**Comments of the Natural Resources Defense Council (NRDC) on the 2011 IEPR –
*Electricity, Natural Gas, and Transportation Energy Preliminary Forecast***

Docket Numbers 11-IEP-1C, 11-IEP-1K, 11-IEP-1L

March 07, 2011

Figure 159: Distribution of Efficiency/Conservation Consumption Savings by Source

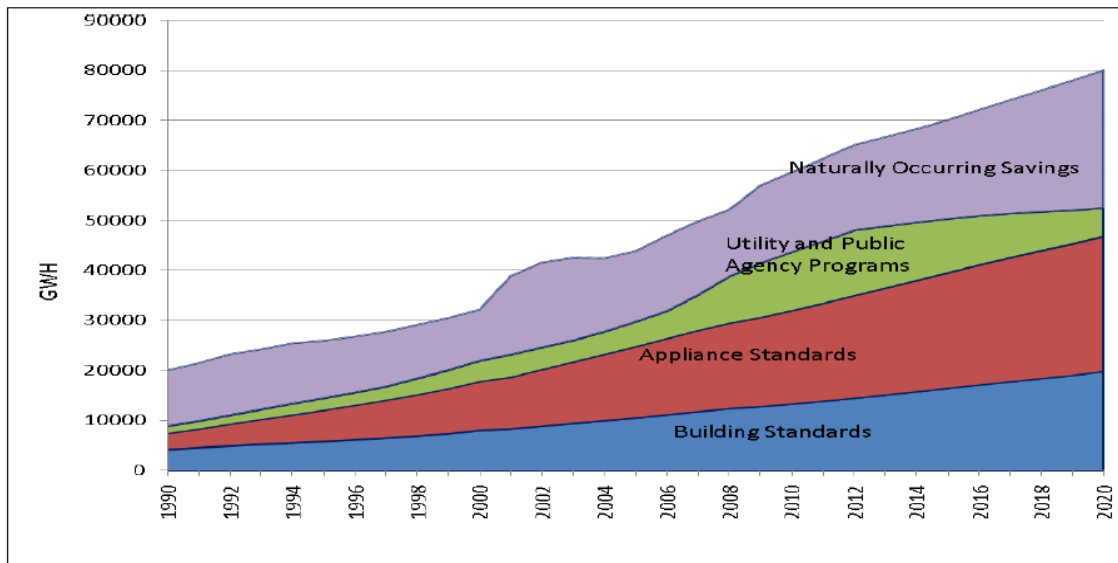
However, in the 2009 IEPR Demand Forecast, the CEC published the following graph that dramatically changed the picture:

The CEC's 2009 graph reduces the cumulative savings attributed to utility programs **by over 75%.**⁴ In some historical years, the savings attributed to utility programs were reduced by 92% (i.e., the CEC only used 8% of the savings that were reported in those years).⁵ These extreme reductions were made without an adequate public process before the CEC, conducted in the absence of any evaluation studies by or on behalf of the CEC, incommensurate with CPUC evaluations of historical savings, and incommensurate with similar estimates of efficiency in similar neighboring regions. For these reasons, among others,⁶ it would be unreasonable if the CEC were to adopt these drastic reductions of savings attributed to utility programs.

4. We recommend that the 2011 IEPR retract the graph attributing historical energy savings to various policies and sources that was presented in the 2009 IEPR since the depiction of savings from utility programs was inaccurate.

In the 2009 IEPR, the CEC acknowledged that uncertainties remained regarding attribution of savings in the demand forecast: "Staff made no assumptions concerning interactive impacts between utility programs and market changes, potentially underattributing savings effects of utility programs."¹⁰ Additionally: "Because higher rates may spur both voluntary actions and participation in utility programs, some naturally occurring savings may be attributable to utility programs."¹¹ Since 2009, additional uncertainties about the process to determine attribution have surfaced, as described above.

In addition to the technical reasons why the 2009 graph should be retracted, there are significant policy concerns about such a portrayal of energy savings. If policymakers were to erroneously conclude based on the 2009 IEPR graph that efficiency programs have had little effect and that savings would have largely occurred without programs to overcome market barriers, it could severely undermine the state's commitment to energy efficiency. NRDC recommends that the CEC retract the graph of historical energy savings attributed to various policies and sources, from the 2009 IEPR.

- We recommend that the 2011 IEPR retract the graph attributing historical energy savings to various policies and sources that was presented in the 2009 IEPR since the depiction of savings from utility programs was inaccurate.
